Project Memorandum

To:	KGHM Ajax Mining Inc.	Doc. No.:	BGC-030
Attention:	Todd Goodsell	cc:	
From:	Cassandra Koenig, Trevor Crozier	Date:	April 25, 2017
Subject:	Ajax Project EA/EIS – Response to GW Solutions (2017)		
Project No.:	1125011

2.1. GW Solutions' Comments on KAM's Response to Pumping Test Interpretation

2.2. Figure 1. Pumping Test Interpretation for BGC10-PW01.

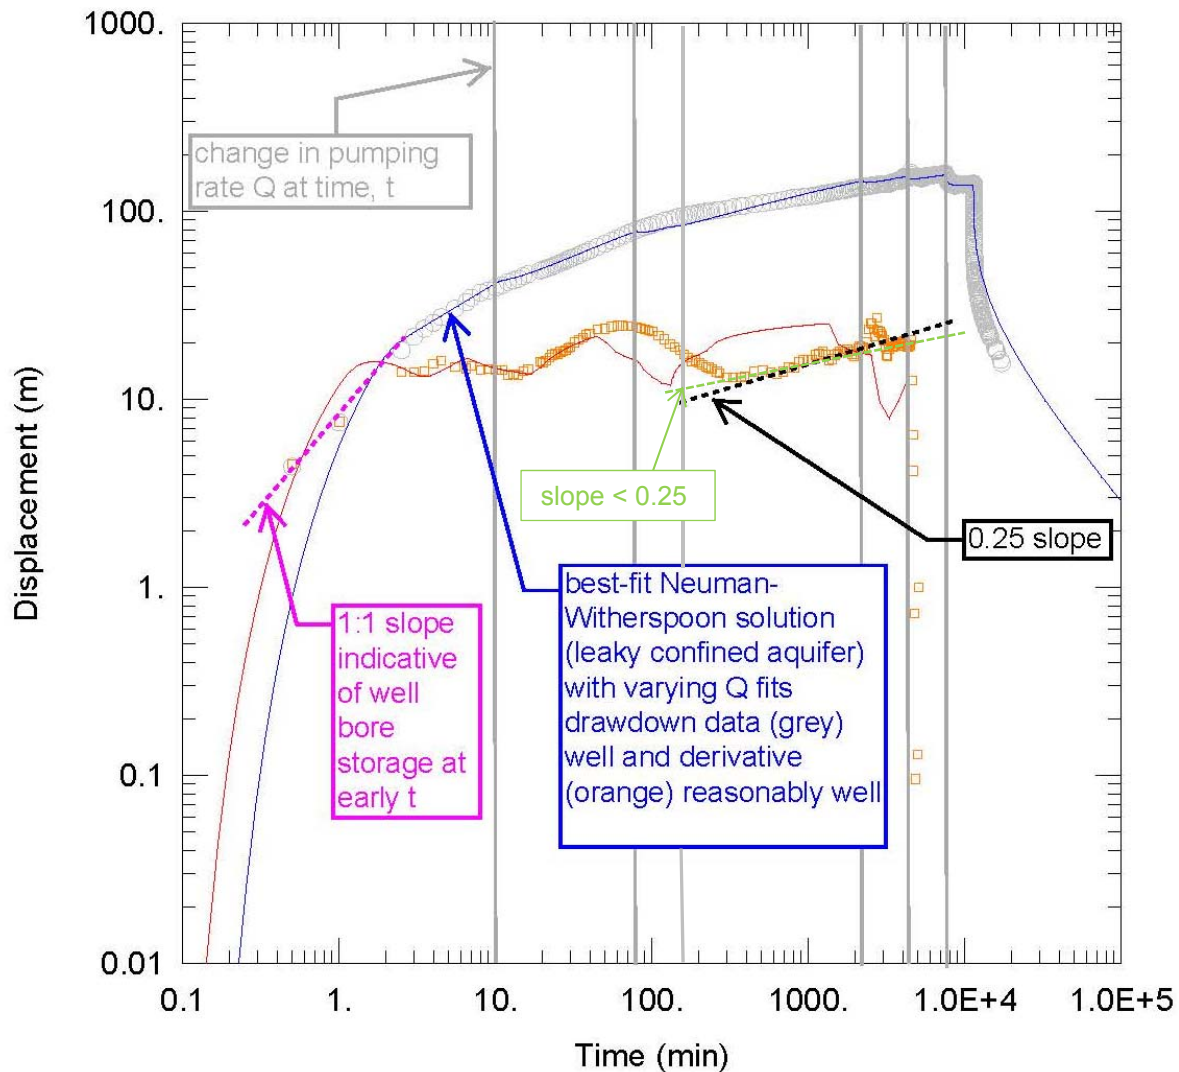
GW Solutions suggested the dual porosity approach in its first review of the pumping test relying solely on the graph provided by KGHM (see Figure 1a). After receiving the raw data for this pumping test, GW Solutions clearly highlighted (Figure 1b) that the behavior of this aquifer is governed by the presence of a conductive fault as shown by the typical slope of 0.25 in the log-derivative curve. In addition, the delayed signature of the bilinear flow indicates that the fault is

not physically and directly connected to the well (i.e., the pumped well does not go through the fault); but instead, it is a major drain close to the well. The recharge boundary would likely be located along the axis of this fault. GW Solutions wants to emphasize that this interpretation is based on actual data, which is more reliable than a model. Moreover, after receiving local geological information on fracture location, this conclusion is well supported. Figure 5 (residual drawdown in monitoring wells as function of t/t') provided by KAM shows that the recovery of drawdown after pumping test does not compensate ideally, and it has been interpreted by KGHM as an aquifer of limited extent (i.e., the presence of barrier boundaries), giving the general reference of Driscoll (1986). GW Solutions believes that the interpretation given by Driscoll (1986) and adopted by KGHM is too general and that other interpretations can explain the fact that the water level does not return to where it was at the beginning of the pumping test after 7 days of recovery. A possible interpretation is that the rate of recharge from the lake is less than the recovery rate in the wells. This recharge rate might be increased with the creation of the open pit. The fact that the recharge from the lake is significant or not is subjective.

GW Solutions has presented the opinion that the behavior of “the aquifer” (i.e., the groundwater flow system within bedrock near Jacko Lake) is governed by the presence of a conductive fault as shown by the typical slope of 0.25 in the log-derivative curve of late time data for one well, which is not identified in the Reviewer's comment (GW Solutions, 2017; Figure 1b). BGC has

GW Solutions interprets that a levelling of the drawdown curve in BGC10-PW01 at late time and a negative slope to the derivative indicates a recharge boundary was reached, and expresses the concern that this recharge may be supplied by Jacko Lake along an assumed drain feature. However, GW Solutions fails to point out that data collected at a pumping well data can be quite “noisy” (i.e. unexplained variation across data) in response to many factors either acting independently or cumulatively (e.g., turbulent flow across the well screen or towards the pump intake, the adjustments needed to maintain a constant discharge rate and to maintain adequate submergence of the pump in the well to prevent overheating or running the pump dry).

While the 0.25 slope of the derivative curve is frequently indicative of a condition called “bilinear flow”, GW Solutions fails to point out that bilinear flow occurs primarily in wells with low conductivity hydraulic fractures (http://petrowiki.org/Diagnostic_plots Plots published by Society of Petroleum Engineers (SPE)). Bilinear flow in a conductive feature affecting a pumping well will more commonly be evident from a 0.25 slope diagnosed in the early time response of the pumping well (<http://www.aqtesolv.com/pumping-tests/derivative-analysis.htm>), and not at the later time response data noted by GW Solutions. GW Solutions explains the delay by inferring that this “major drain” feature is not physically and directly connected to the pumped well. A slope of 0.25 at later time might be used to interpret the presence of a compressible aquitard overlying a confined leaky confined aquifer or a channel aquifer (<http://www.aqtesolv.com/pumping-tests/derivative-analysis.htm>). A positive slope at late time may also simply indicate that drawdown in the aquifer is continuing in a pseudo-steady state condition (i.e. the groundwater level is being drawn down, and no boundaries have influenced the rate of drawdown).

The GW Solutions hypothesis that a “major drain” feature governs the behavior of the aquifer is not supported by other data that must be considered before this conclusion can be drawn. Specifically, if a major drain feature were present and governing the behavior of the aquifer, then similar responses (i.e., a 0.25 slope to the derivative) would be observed at other locations used to monitor responses to pumping at BGC10-PW01. To investigate the GW Solutions hypothesis, BGC reviewed the data from the pumping test conducted at BGC10-PW01 in 2011 (BGC 2011)¹. BGC confirms that during the 2011 test, this condition (i.e., a 0.25 slope to the derivative) was not present in any of the other wells and observations points where drawdown responses were observed (Appendix A). Since this behavior was not observed in any of the locations monitored in the BGC (2011) pumping test, it is unlikely that the response examined by GW Solutions in the pumped well in the KCB (2014) pumping test indicates the presence of a conductive fracture that governs behavior of the aquifer. A local scale, discrete fracture may exist near the pumped well, but the lack of similar responses in the other monitored locations confirms that this feature does not govern behavior of the aquifer. Furthermore, the drawdown response (and therefore the derivative response) noted by GW Solutions in the KCB (2014) pumping test was likely affected by other factors such as adjustments to pumping rate. This is discussed further in Section 2.1.2.2.

Adjustments to pumping rate can affect both the well drawdown response and the slope of the derivative curve. BGC has not reviewed the KCB (2015) pumping data in detail to evaluate if this was a possible explanation for the slope change during the 2014 pumping test² but did review the drawdown and pumping rate records for the BGC (2011) test. The following points present the logic and evidence against the presence of a recharge boundary noted from this review:

becomes negative at this point in the pumping well record (Figure 1). Consistent with the GW Solutions technical commentary, this indicates recharge to the well, but in response to a pumping rate change and not in response to the intersection of a recharge boundary.
